# Administrative Approval Action

Case File / Name: ASR-0063-2024  
DSLCL - ARBORETUM PARTNERS CLOVER LANE

- REQUEST:** The development plan proposes a five-story apartment consisting of four levels of multi-unit living and one level of parking. The project includes 280 units, 316 parking spaces (surface and structured), amenity areas, site lighting, bicycle parking, and other site improvements. Total proposed building space is 274,991 square feet.

**TREE PROTECTION & CONSERVATION PLAN**

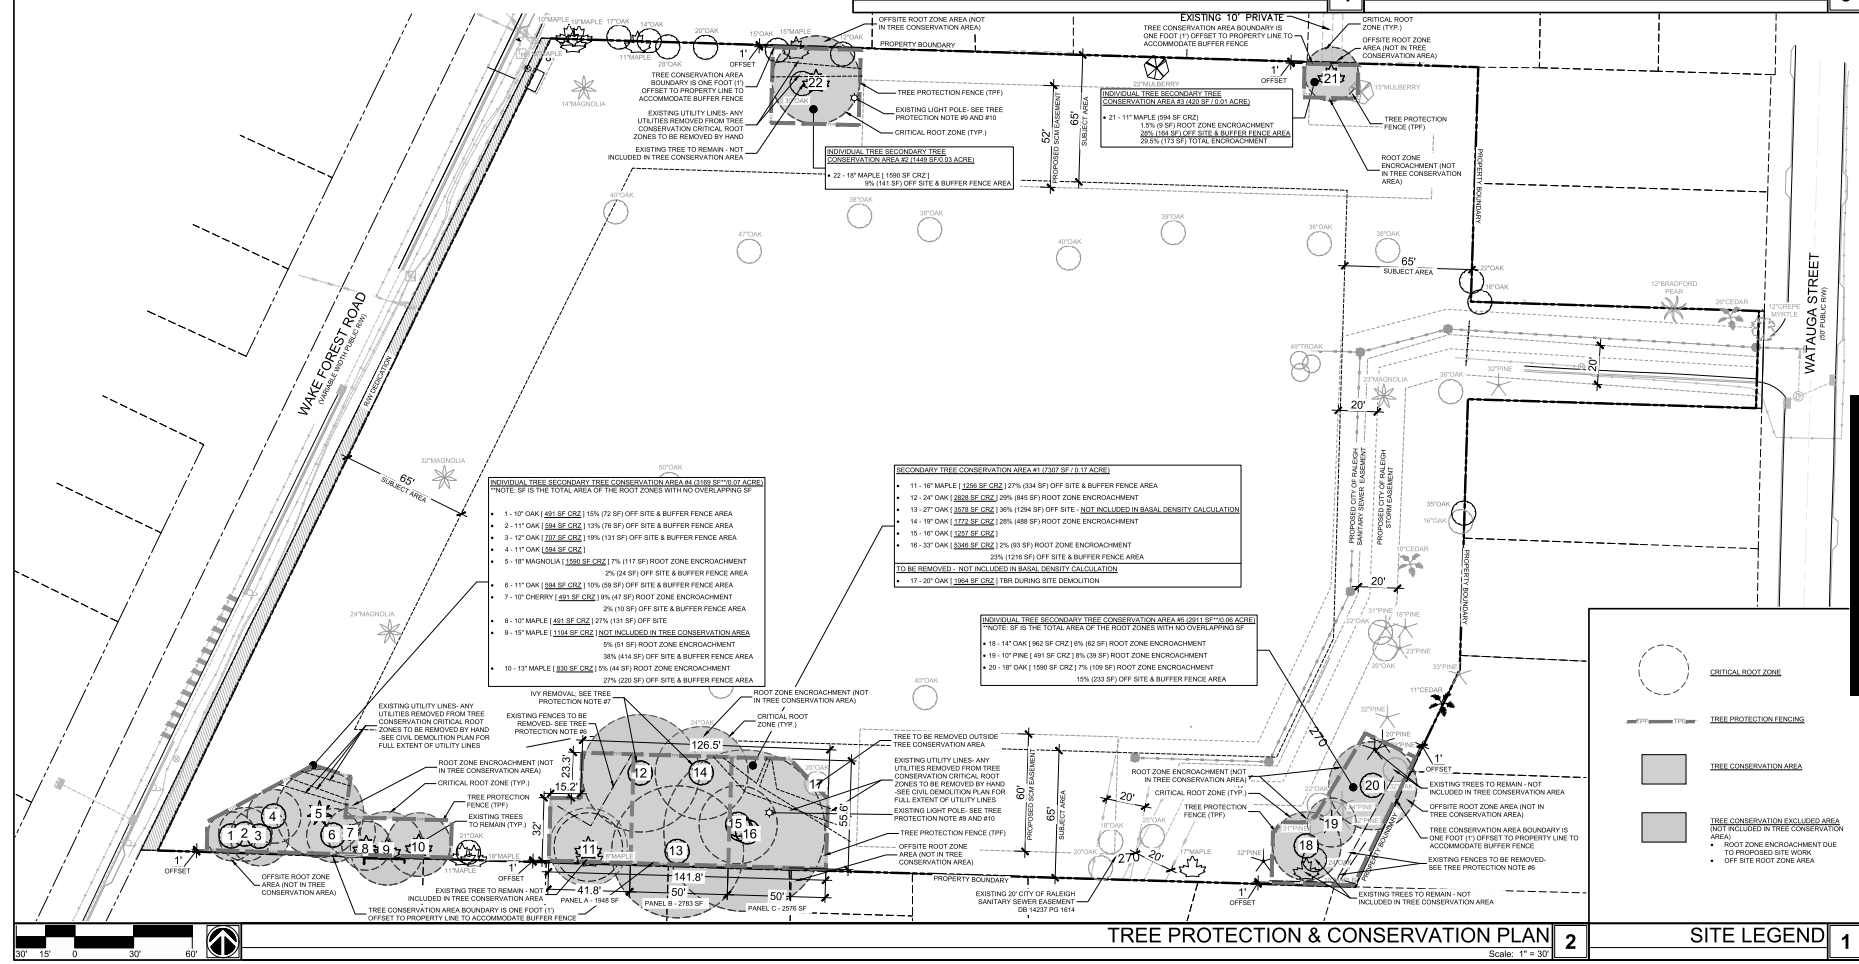
12. Submit a final tree conservation plan that includes metes and bounds descriptions of all tree conservation areas and tree protection fencing as required (UDO 9.1.5).
13. Tree protection fence must be inspected by Urban Forestry staff prior to the issuance of a grading permit or demolition permit, whichever comes first.
14. Submit a schedule for the timing of the removal of invasive English ivy on trees within the 0.17 acre Secondary Tree Conservation Area.

OVERALL SITE LIGHTING PLAN 1  
Scale: 1" = 30'

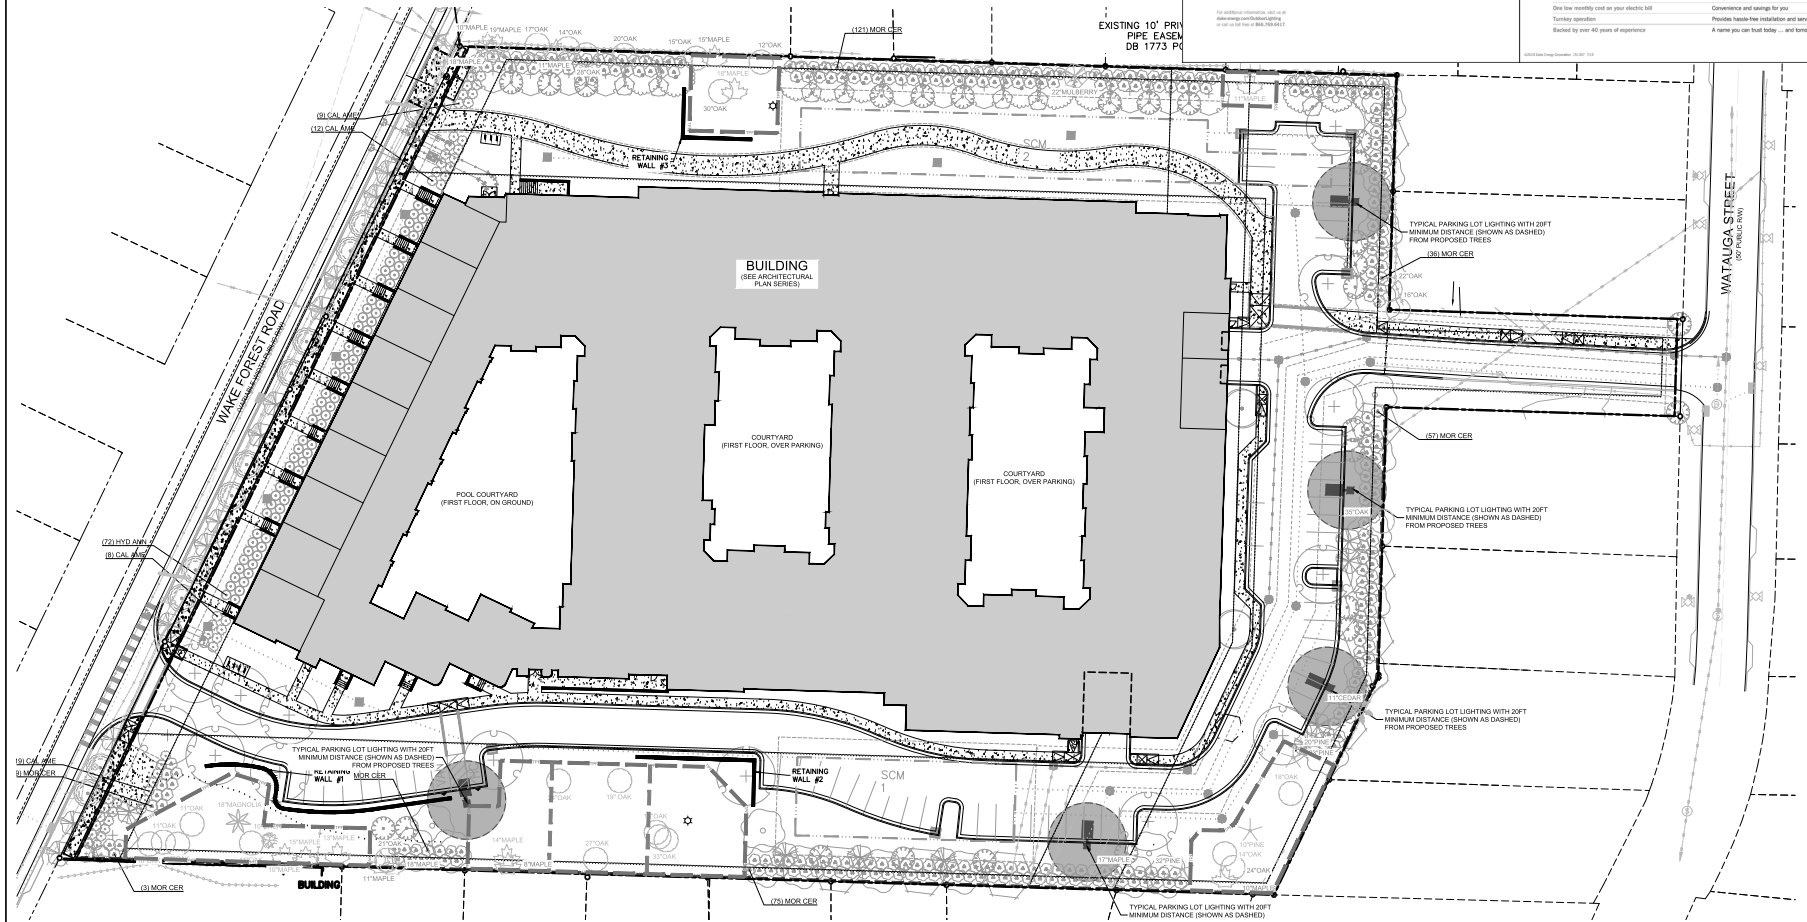
3. Prior to SPR approval, provide a full lighting plan that is compliant with UDO Article 7.4 and other applicable standards. This includes specific information on fixture cut sheets, footcandle array, and distance of pictures to exterior property lines. If any exterior building lighting is proposed, this shall also be included on the plans.

ELEVATION FACING CLOVER LANE TO EAST **EAST ELEVATION** 4  
1" = 30'-0"

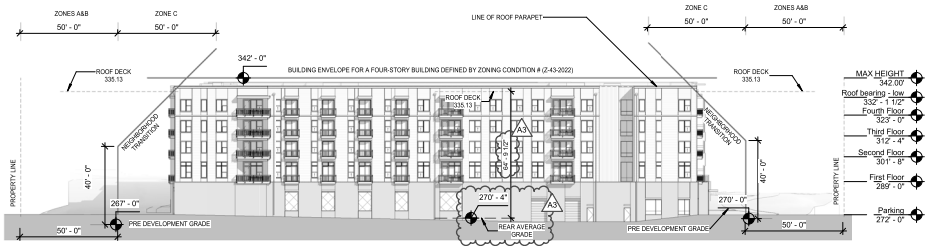
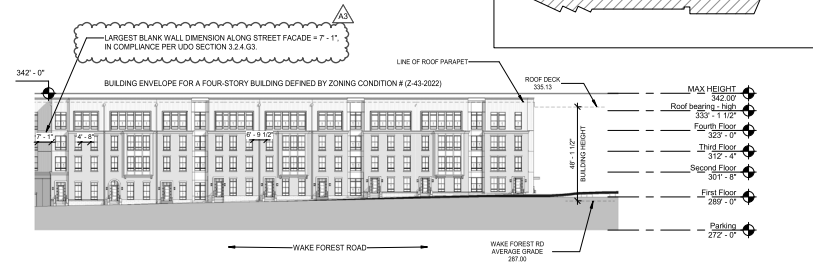
5. Transparency is not applicable for residential portions of the building. Remove calculations for transparency from building elevations (Sheet A02), unless non-residential uses will be located on ground level and upper stories of the building.
6. Plan shall show compliance with Green (-GR) Frontage Build-To requirements (UDO Section 3.4.6.C). The build-to lines (minimum and maximum) shall be shown on the site plan.
7. Demonstrate compliance with e-bike requirement set forth in condition number 12 of Z-043-2022.
